Memorandum

Date: April 5, 2019
To: James Martin
Company: The Sunshine Mill Winery
Project: Wall Opening Evaluation
The Sunshine Mill, The Dalles, OR
Project No.: 190612
C: Dave Peden
From: Steve Hawk

PHOTO 1: PROPOSED OPENINGS IN MILL BUILDING

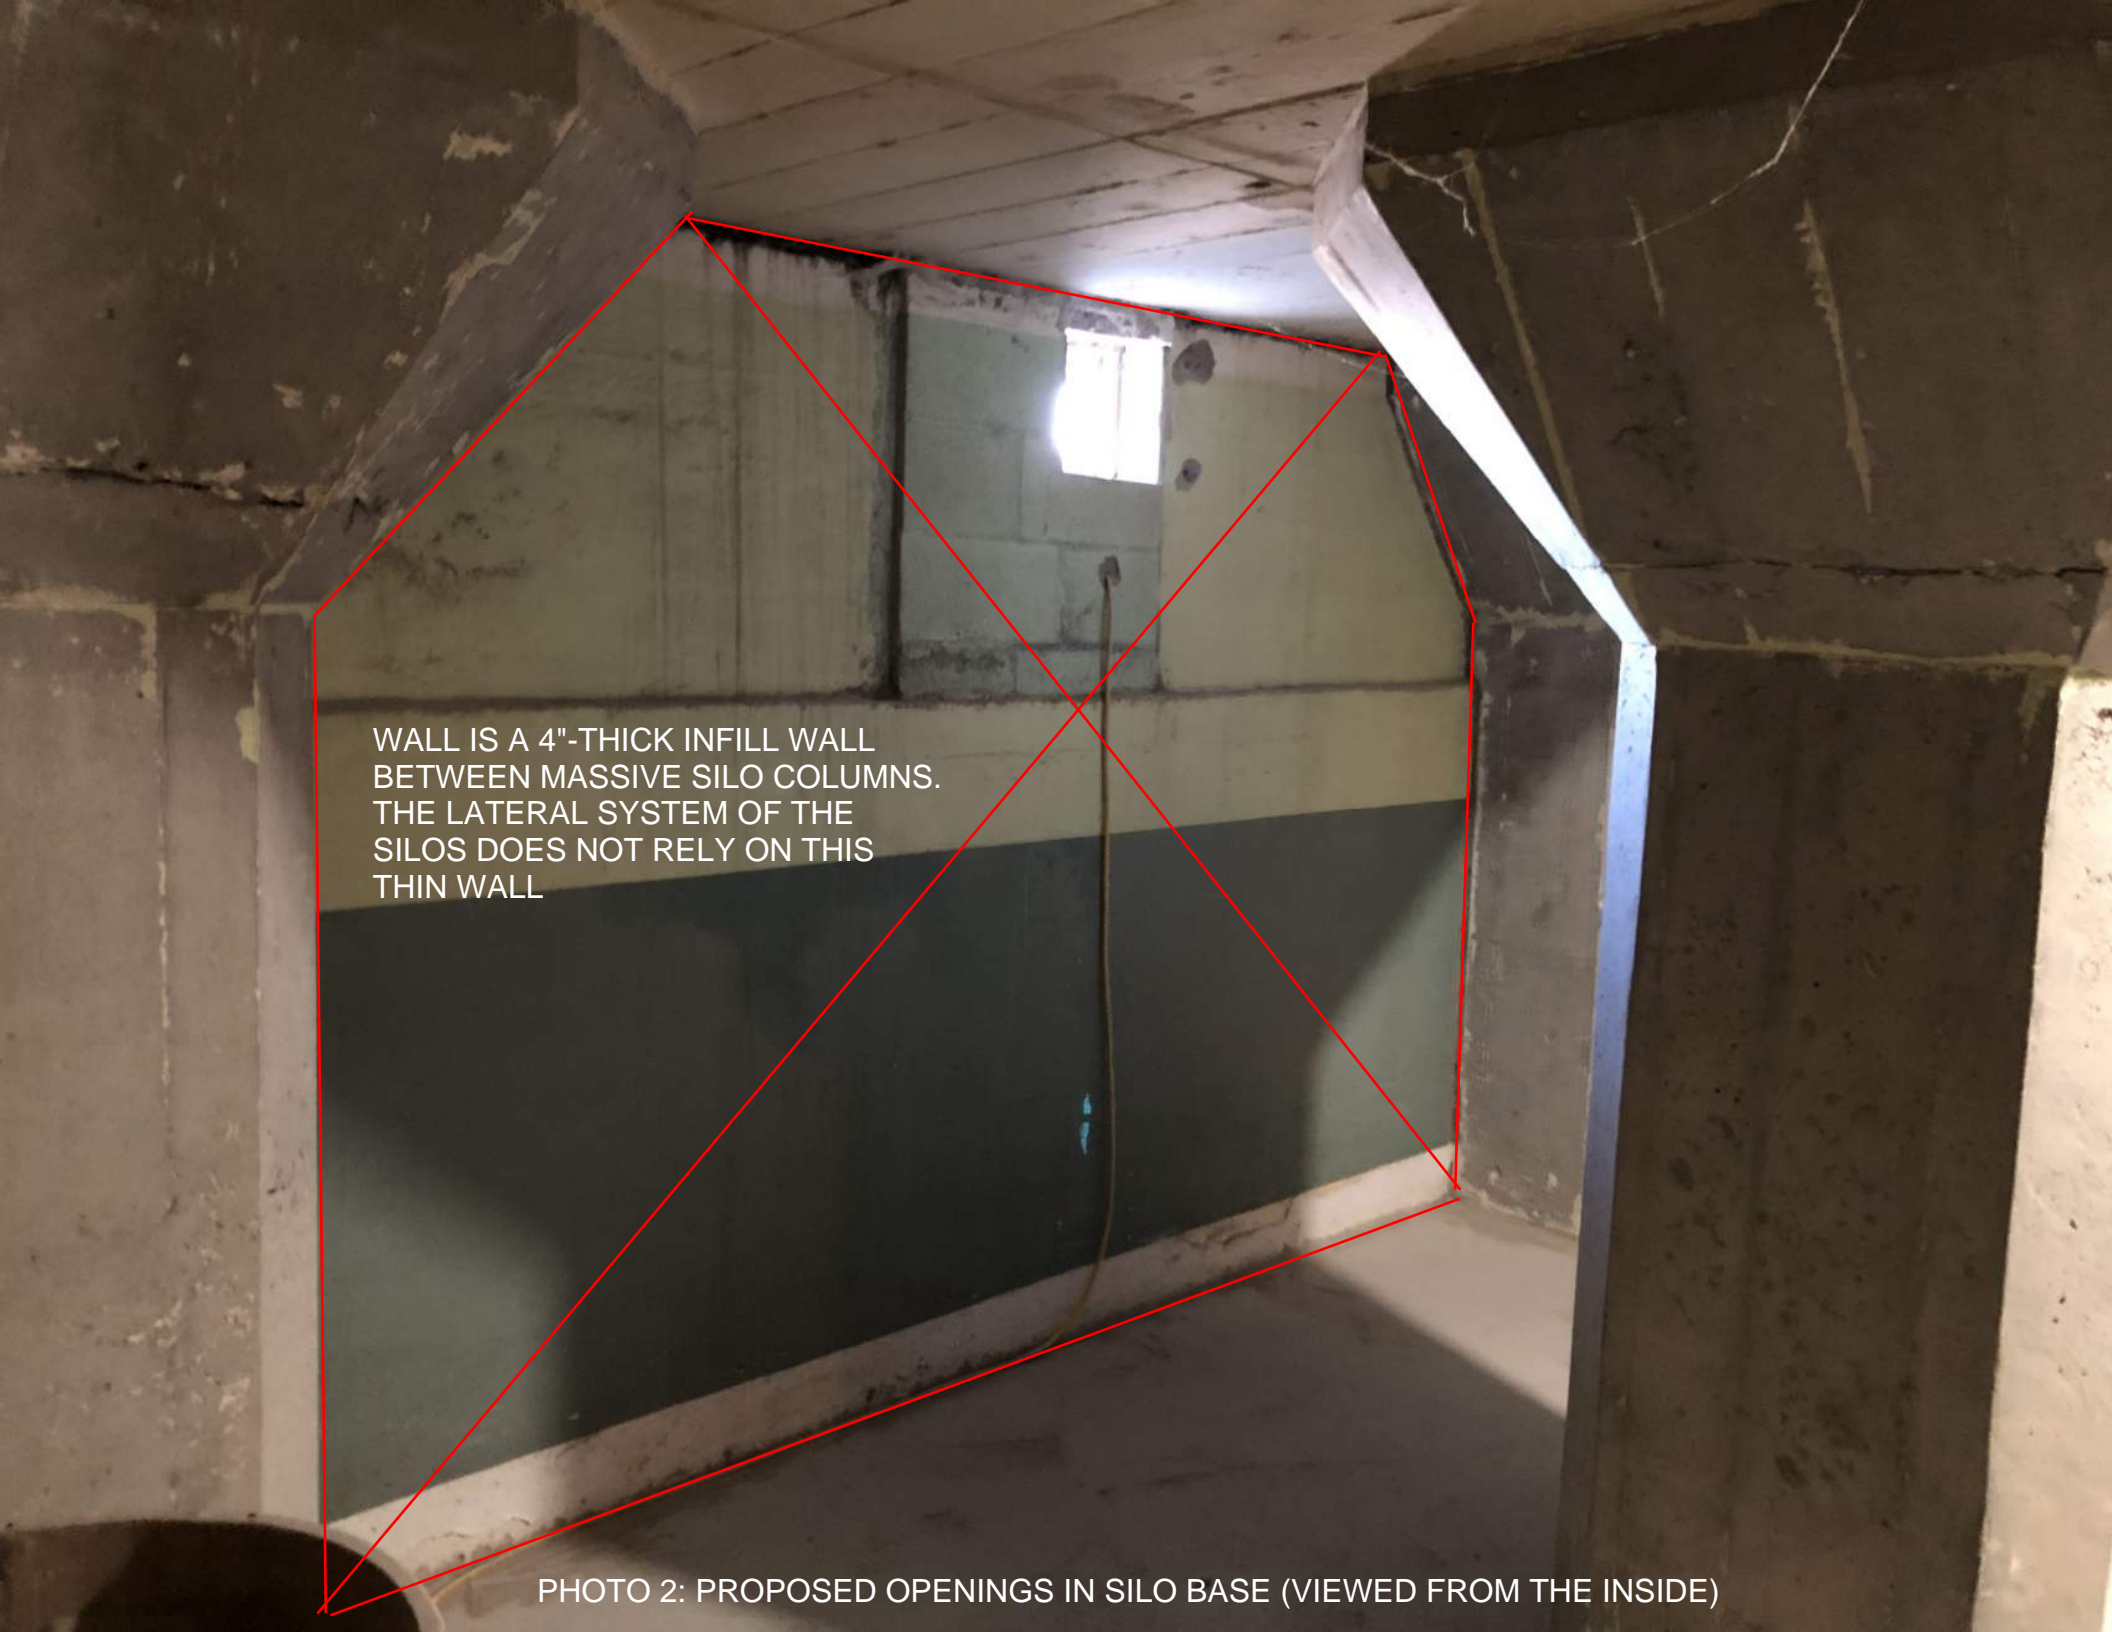
SHEAR WALL
"PIERS" TO
REMAIN
BETWEEN
OPENINGS

PROPOSED
OPENING, TYP

THIS OPENING PROPOSED
TO EXTEND BELOW
GRADE AS A NEW
BASEMENT ENTRANCE
